SUBSURFACE WASTEWATER DISPOSAL SYSTEM APPLICATION

City, Town, or Plantation	BLUE HILL
Street or Road	641 FALLS BRIDGE RD.
Subdivision, Lot #

SUBSURFACE WASTEWATER DISPOSAL SYSTEM VARIANCE REQUEST

Subject: Approval, Replacement System Variance Request, Adam Cousins Property, 641 Falls Bridge Road, Blue Hill, Maine. Mailing Address Of; PO Box 691, Blue Hill, Maine.

SUBSURFACE WASTEWATER DISPOSAL PLAN

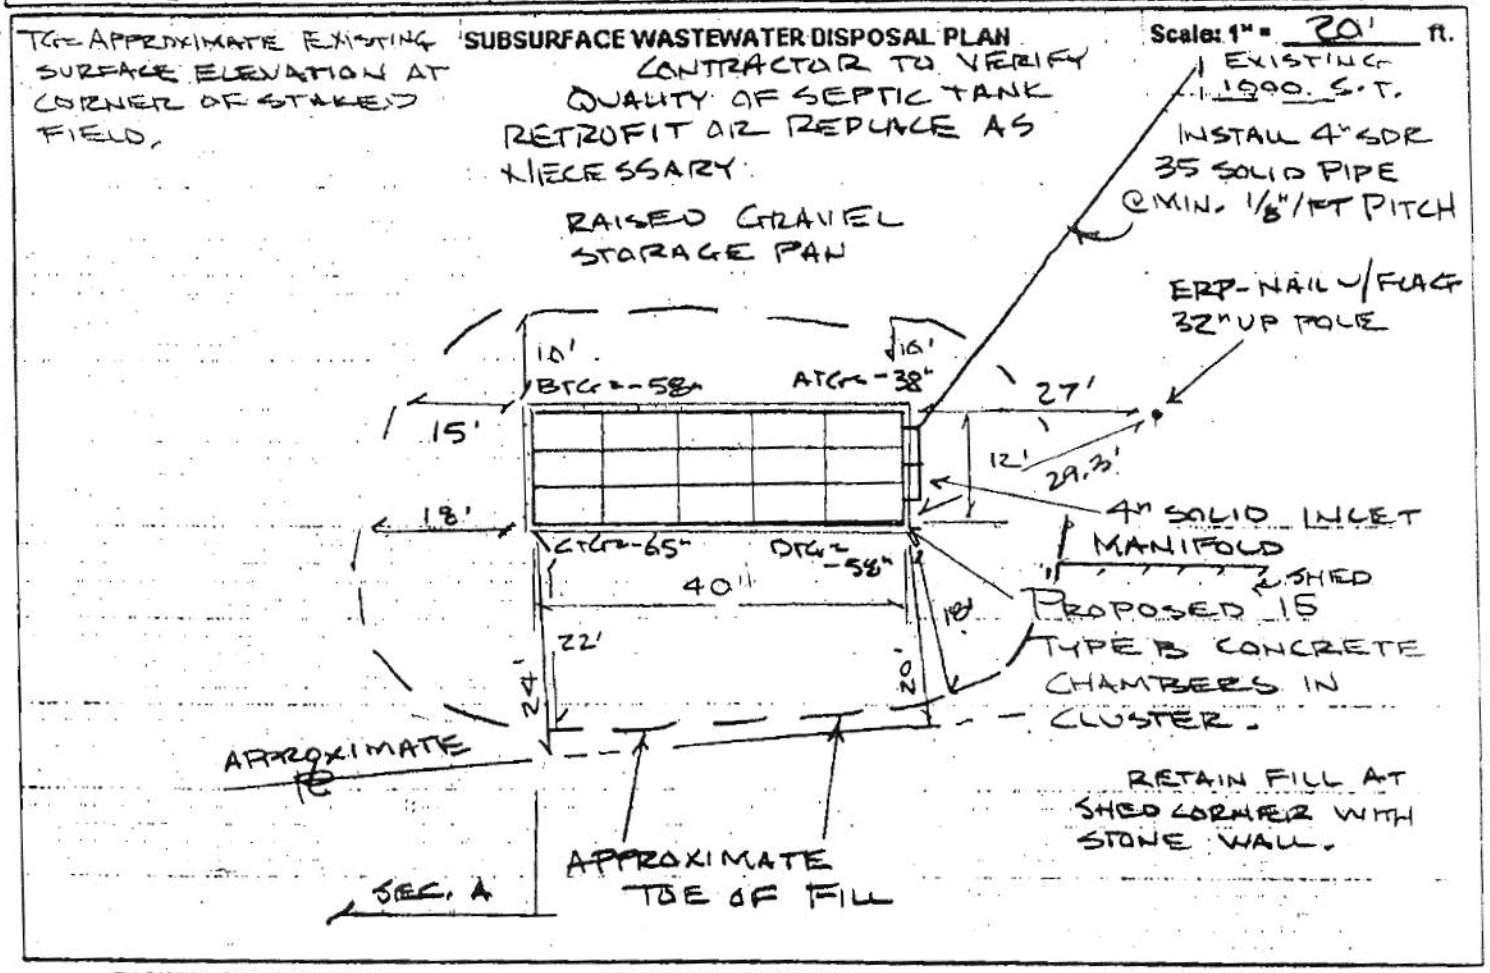
SECTION OF RULE
1. SEASONAL WATER TABLE @ 6 INCHES	TABLE 4E
2. OWNER'S WELL SETBACK TO CHAMBERS @ 85FT	TABLE 8A
3.

POORLY DRAINED 3E SOILS ARE LOCATED UNDER NW CORNER OF PROPOSED FIELD - A 24" SEPARATION IS MAINTAINED BETWEEN 3E SOIL @ 6" AND BOTTOM OF CHAMBERS. SOILS TO BACK OF LOT ARE 3E SOILS TOWARD ROAD HAVE REDUCED WELL SETBACKS

The variance requested which is not within the LPI's authority is to the seasonal high-water table of 6 inches.

The variances requested that is within the LPI's authority is from the disposal field to a potable water supply of 85 feet.

We approve the local requested variance with the following requirements:

2. The system is to be installed in accordance with the submitted and approved system design. Should alterations to the design be required at the time of construction, the site evaluator is to be notified prior to making any changes.

3. The contractor is to scarify the soils under the fill extensions to create a transitional zone more compatible with the disposal field area.

DISPOSAL FIELD CROSS-SECTION

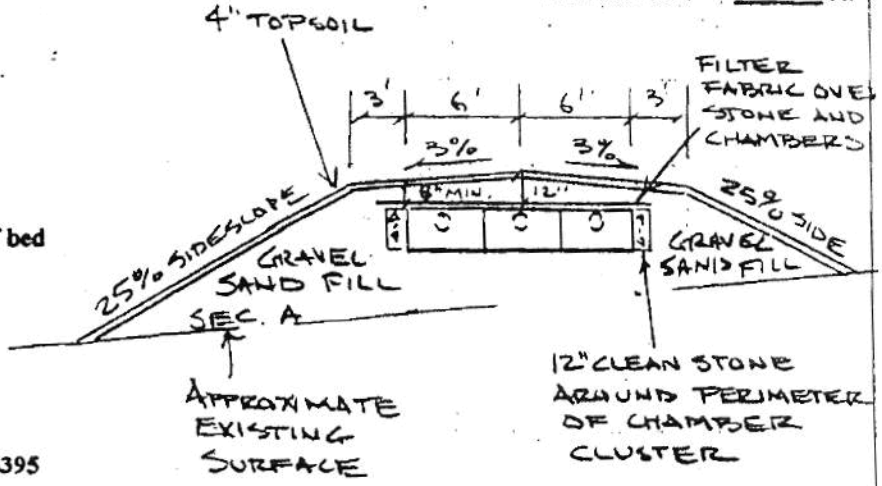
1.) Scarify original surface under Disposal Field and fill extension.
2.) Place gravelly coarse sand fill in 8 " lifts, incorporate into underlying original soil.
3.) Disposal Field to be level with a maximum grade tolerance of 2"/100 ft.
4.) Lime, fertilize, seed & mulch, top and sides of bed and all disturbed areas to prevent erosion.
5.) See Chapter 8 of code for additional requirements.
6.) Bottom of disposal field to be 46" below elevation of TBM (ERP).
